**Harker Heights
Planning and Zoning
Commission
Meeting & Workshop**

PRELIMINARY PLAT OF: STONE LAKE TRAILS F.M. 2410, Bell County Rural, Texas

**MASTER UTILITY PLAN OF:
STONE LAKE TRAILS**
134.832 ACRES 5,873,300.37 S.F.
117 LOTS, 3 BLOCKS AND 4 TRACTS INCLUDING:
11,157.41 L.F. OF NEW STREETS AND 698,422.79 S.F. OF R.O.W.
JOHN HUGHES SURVEY, ABSTRACT #379, BELL COUNTY TEXAS
A SUBDIVISION IN THE ETJ CITY OF HARKER HEIGHTS, BELL COUNTY TEXAS

Plat Distributed to HH Staff: June 3, 2021

PRELIMINARY PLAT
(SHEET 1 OF 5)

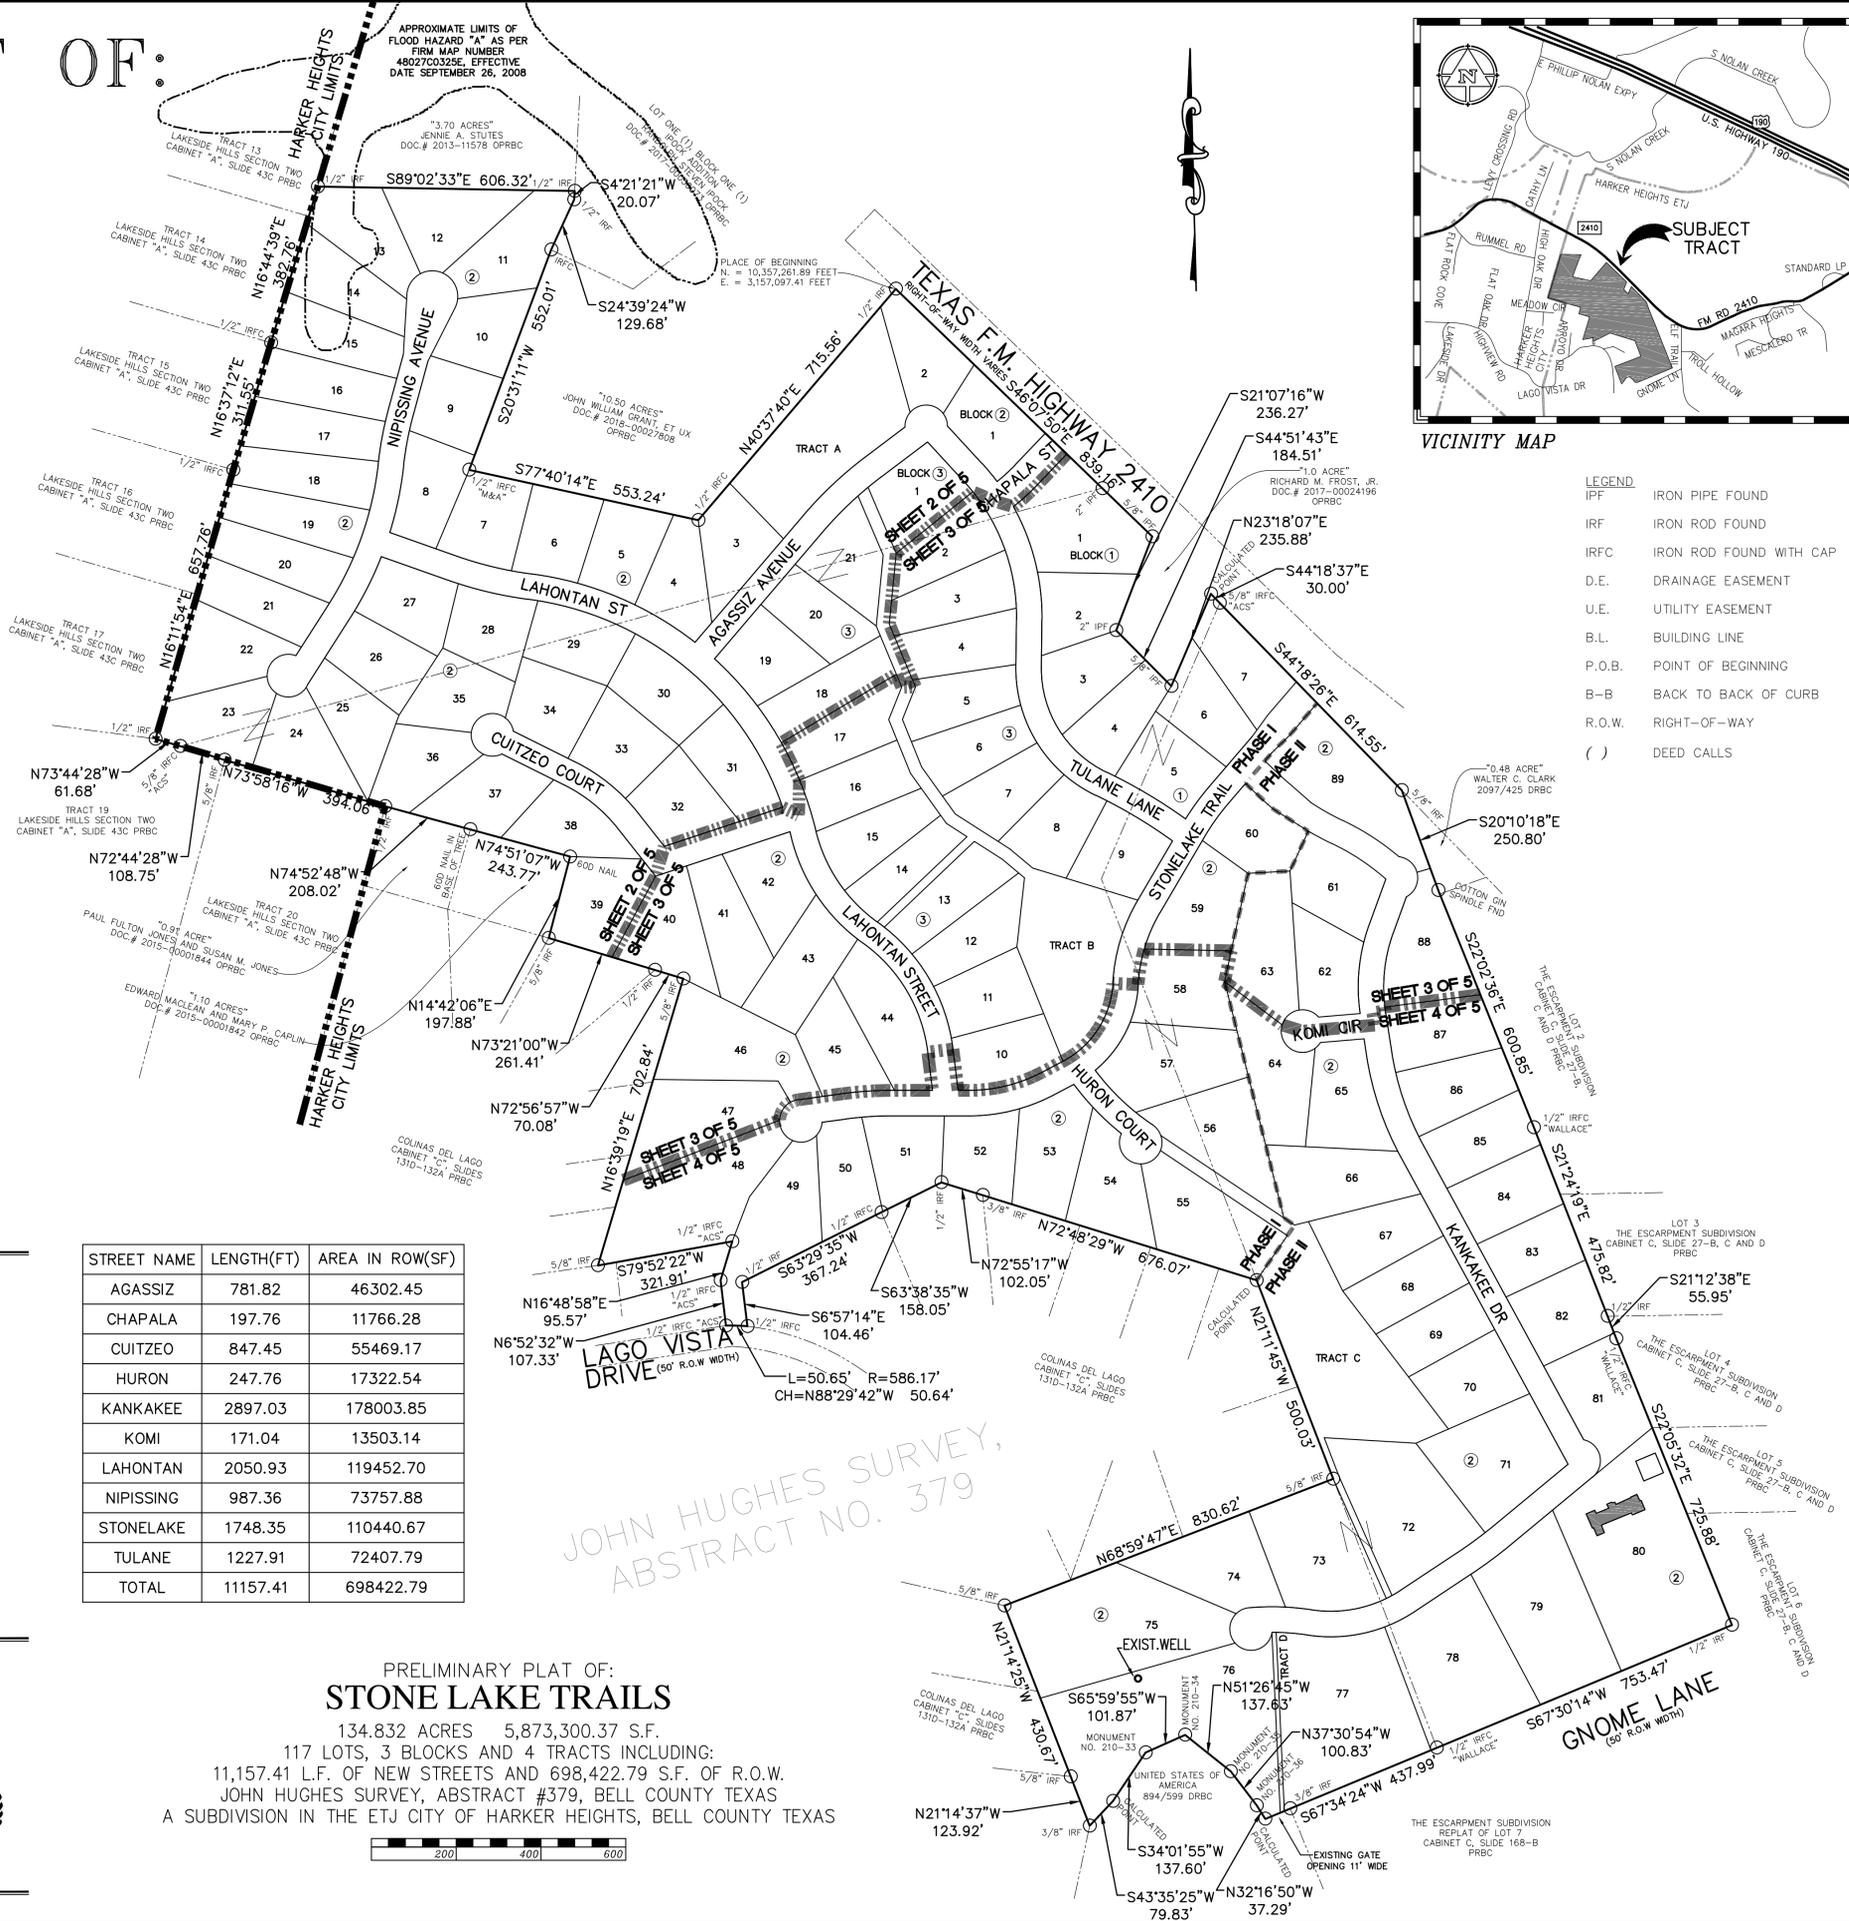
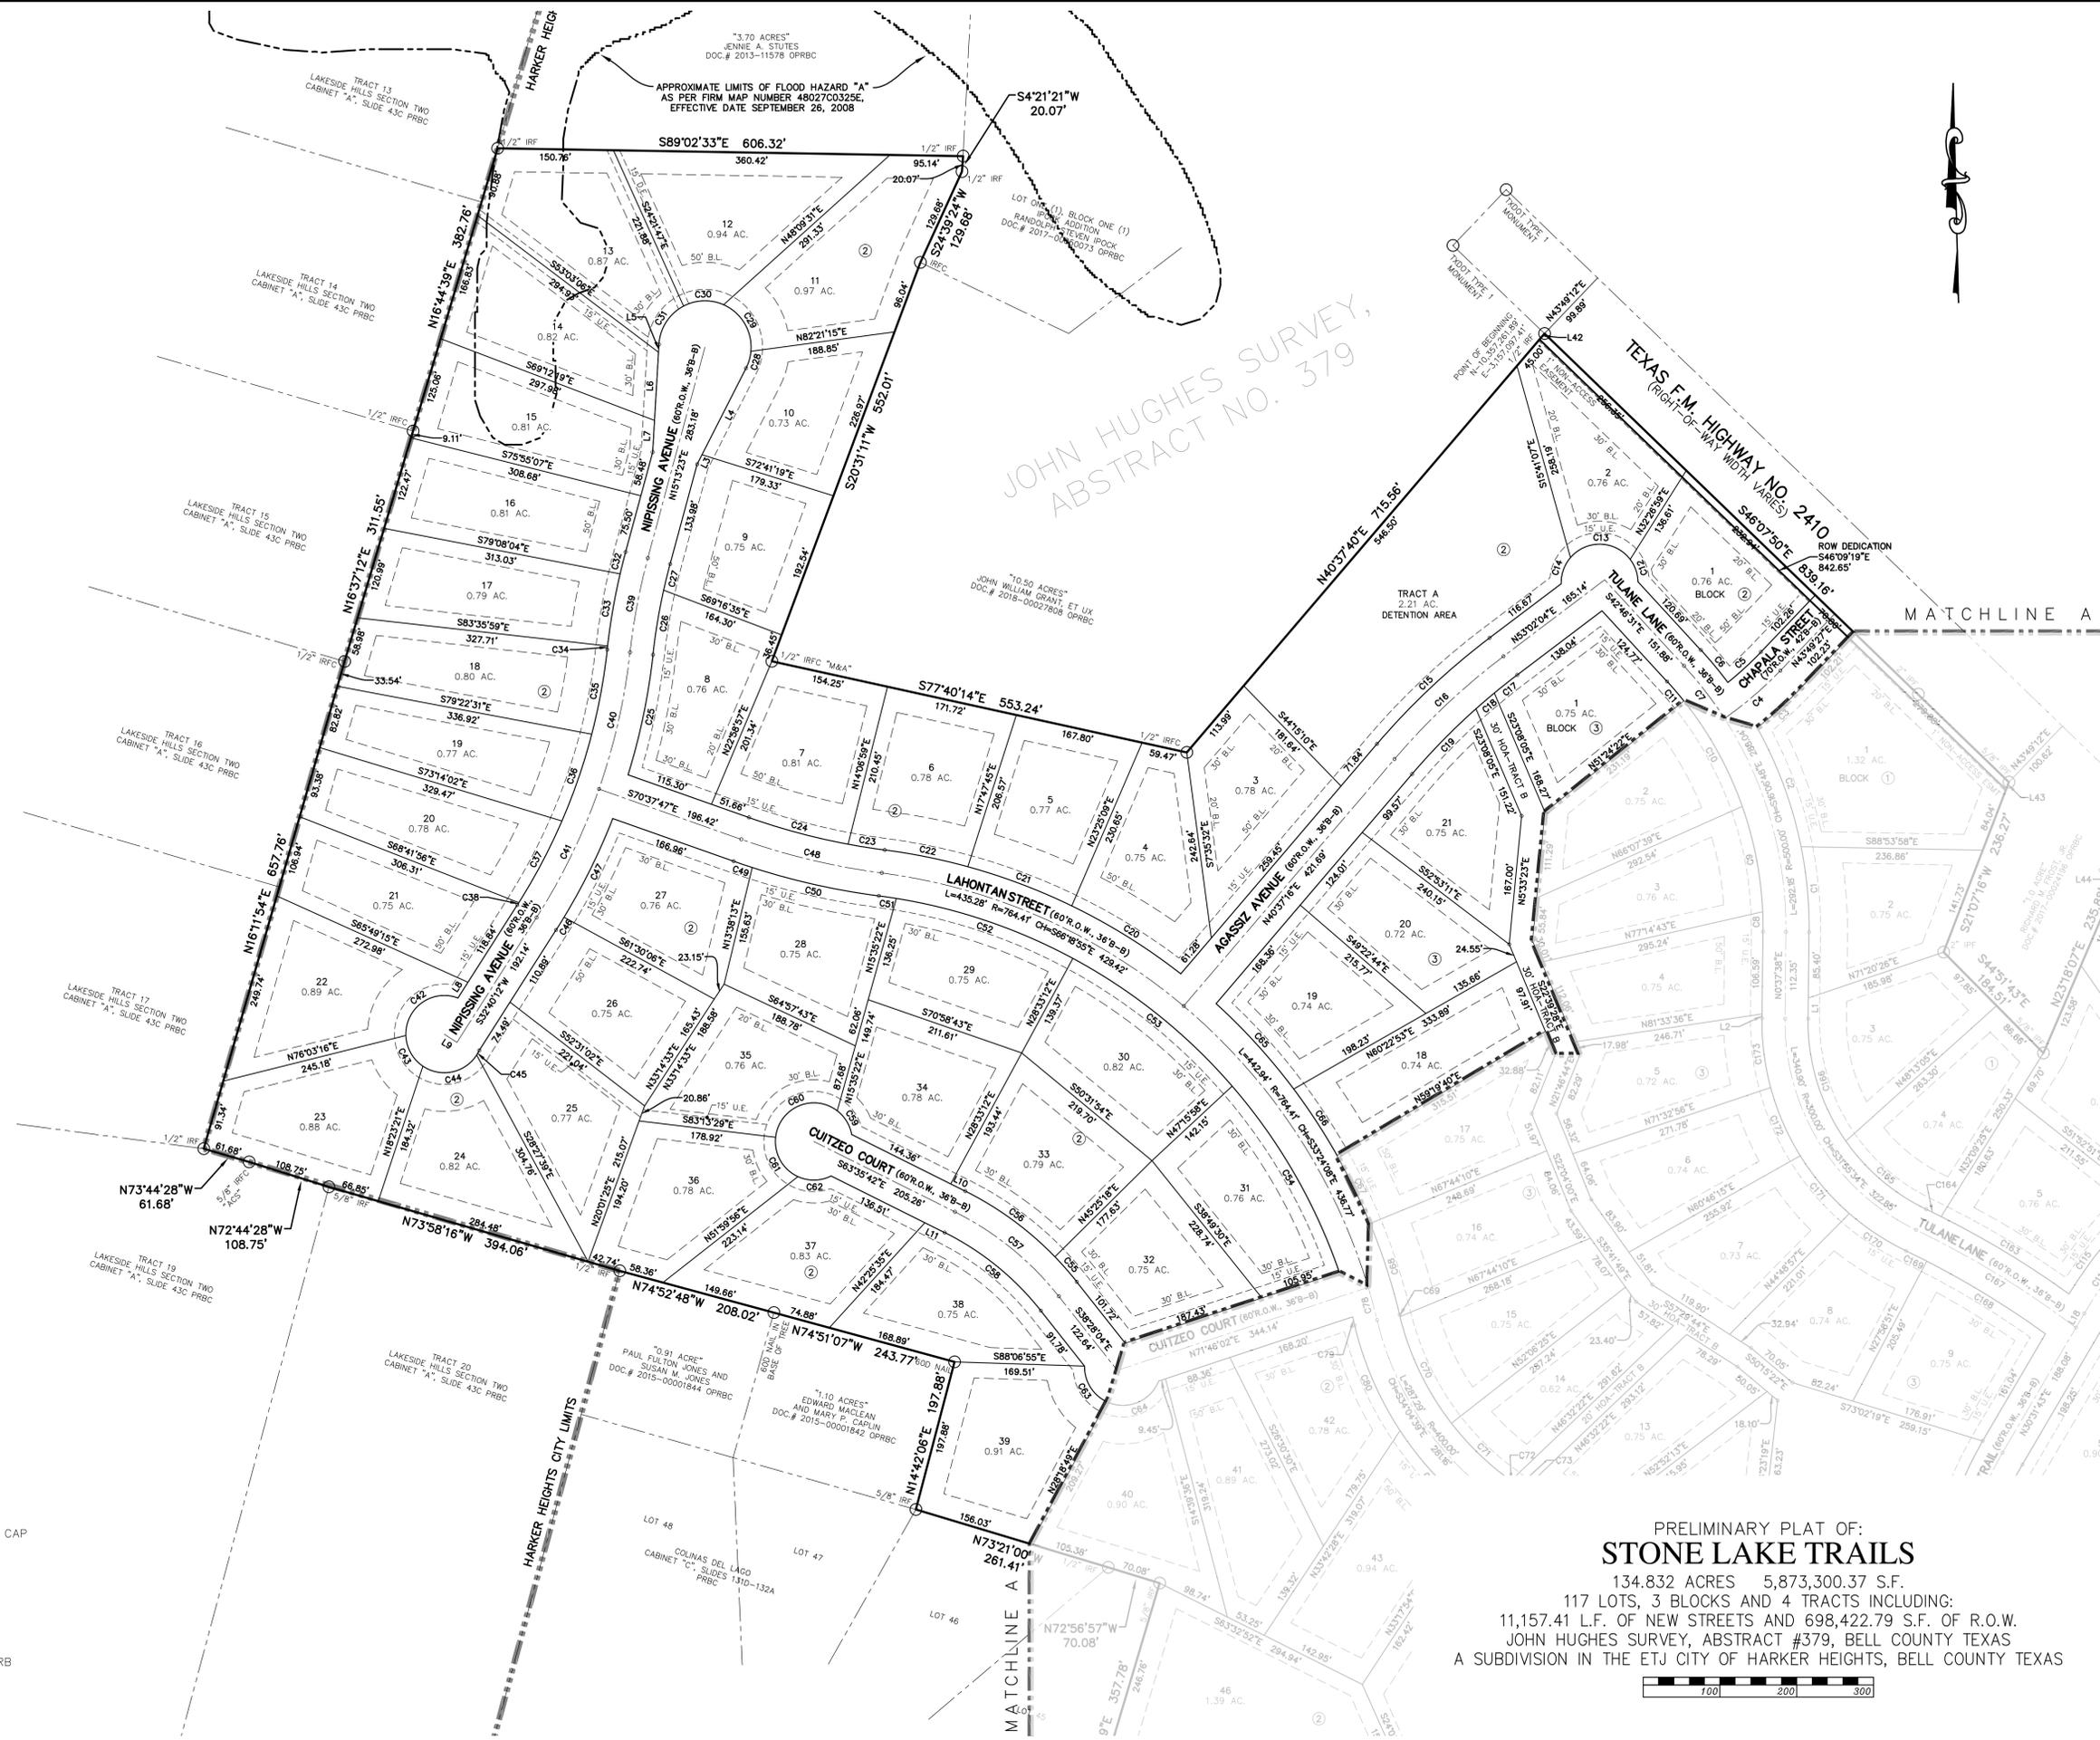
1. Applicant is advised that a concept plan submission is required prior to or with submission of a preliminary plat per §154.20(A)(2)(e).
2. Applicant shall provide a detail with typical building placements and building envelopes.

3. Applicant shall provide half of the lacking right of way to meet the 120' required width along those lots that abut FM 2410 (major arterial).
4. Per §154.37(D)(7), Applicant shall amend the subdivision layout such that the length of Kankakee Drive does not exceed the allowable culdesac length for lots less than 1 acre.

7. Applicant shall clarify the sheet and phase linework such that they are discernable in black & white and when reproduced (different line types).
8. On page 1 of the plat dedication pages, applicant shall provide uniform annotation for all surrounding parcels (lot/block information, subdivision name, type of use for a distance of 300 ft from the plat boundary).

12. Per §154.20(B)(6) applicant shall provide an as-built for the existing property (structures, OSSF, easements). On some of the plan sheets two structures are shown to be located on Lot 80, Block 2. Clarify the intent for those existing structures.

13. Applicant shall clarify the intent for the existing well located on Lot 76, Block 2.

15. Applicant shall provide for utility easements to the adjacent undeveloped parcels.
16. Applicant shall address how the two landlocked parcels south of Lots 36-38 of Block 2 are accessed (connectivity to public ROW).

17. Applicant shall provide for half of the right of way needed to bring the adjacent Gnome Drive into compliance (Lots 77-80 need to dedicate 5' of ROW) & need to illustrate the same for opposite side (Full ROW should be 70'), same for Lago Vista Drive.

18. Provide concurrence from TXDOT showing approval for curb cuts and drainage acceptance.
19. Applicant is advised that all drainage infrastructure shall be completed in Phase 1 of this development or waivers of liability will need to be executed and recorded.

1. Applicant is advised that a concept plan submission is required prior to or with submission of a preliminary plat per §154.20(A)(2)(e). **6/17/21 Not Met. Applicant's response is noted. However, a Concept Plan application was not submitted with the revisions.**

2. Applicant shall provide a detail with typical building placements and building envelopes. **6/17/21 Partially Met. Applicant's response is noted. However, applicant shall amend Surveyor's note #12 such that it is clear that those are the current setbacks at the time of platting and that setbacks are determined by the adopted zoning district as mended by City Council.**

3. Applicant shall provide half of the lacking right of way to meet the 120' required width along those lots that abut FM 2410 (major arterial). **6/17/21 Partially Met. The right of way dedication being offered with this platting action must be reflected on sheet 1 or a note added to refer to Sheets 2-4 for additional detail.**

7. Applicant shall clarify the sheet and phase linework such that they are discernable in black & white and when reproduced (different line types). **6/17/21 Met.**

8. On page 1 of the plat dedication pages, applicant shall provide uniform annotation for all surrounding parcels (lot/block information, subdivision name, type of use for a distance of

300 ft from the plat boundary). **6/17/21 Not Met.** The following clarification is provided per the applicant's request. One Sheet 1 some parcels that are adjacent to this development are labeled by lots and blocks (The Escarpment Subdivision; Lakeside Hills Subdivision), while others are only identified by the subdivision name (Colinas Del Lago). Additionally, code requires that the usage of the lots within 300 feet of the property boundary be identified. If they are all the same use then that can be added in a note on Sheet 1.

9. Applicant shall illustrate the adjacent offsite and onsite existing 20' drainage easement and address connectivity of said easement (Lots 49-56, Block 2, & Tract C). This point discharge shall be taken into account in the drainage analysis. **06/17/21 Partially Met.** The applicant shall illustrate and annotate all drainage easements (yellow) that continue onto this property and ensure that the existing 15' waterline easement by separate instrument (blue highlight) is shown in the proposed subdivision. Applicant shall provide a copy of the water line easement recorded by separate instrument. Applicant shall verify if there are natural swales or low spots in the existing drainage easement and address how the flow will be conveyed from those locations to the proposed Drainage Tract C and not into a proposed home.

1. Applicant is advised that a concept plan submission is required prior to or with submission of a preliminary plat per §154.20(A)(2)(e). **Noted**
2. Applicant shall provide a detail with typical building placements and building envelopes. **Building setbacks have been provided for each lot.**

3. Applicant shall provide half of the lacking right of way to meet the 120' required width along those lots that abut FM 2410 (major arterial). **ROW dedication lines added to get 120' required for FM 2410.**

6. Applicant shall move the drainage tracts dedication from the subdivision block to after the dedication statement and before the applicant's signature. **Drainage tract dedication added after dedication statement and before applicant's signature. These drainage tracts to be owned and maintained by the Home Owners Association.**

7. Applicant shall clarify the sheet and phase linework such that they are discernable in black & white and when reproduced (different line types). **Linework for changed to add variation between phasing lines and sheet lines.**

8. On page 1 of the plat dedication pages, applicant shall provide uniform annotation for all surrounding parcels (lot/block information, subdivision name, type of use for a distance of 300 ft from the plat boundary). **Comment needs clarification.**

11. On all plat dedication pages, the applicant shall identify usage and ownership for all Tracts (A, B, C & D) in a uniform manner (i.e. each have Tract name and acreage with a note for usage and ownership on the dedication page. On Sheet 5 on the plat, a table is given showing the tract name, acreage, ownership and usage.

12. Per §154.20(B)(6) applicant shall provide an as-built for the existing property (structures, OSSF, easements). On some of the plan sheets two structures are shown to be located on Lot 80, Block 2. Clarify the intent for those existing structures. Please see the attached as-builts for the existing structure. Septic permit and information is also included. Existing easements for this structure were added to the plat.

13. Applicant shall clarify the intent for the existing well located on Lot 76, Block 2. The proposed well is to used for landscape irrigation for Lot 76.

15. Applicant shall provide for utility easements to the adjacent undeveloped parcels. Need clarification for this comment. Which parcels are undeveloped and in need of a utility easement.

17. Applicant shall provide for half of the right of way needed to bring the adjacent Gnome Drive into compliance (Lots 77-80 need to dedicate 5' of ROW) & need to illustrate the same for opposite side (Full ROW should be 70'), same for Lago Vista Drive. See variance letter.

18. Provide concurrence from TXDOT showing approval for curb cuts and drainage acceptance. See attached email showing TxDOT approval of curb cuts. Drainage acceptance to be closer to final plat.
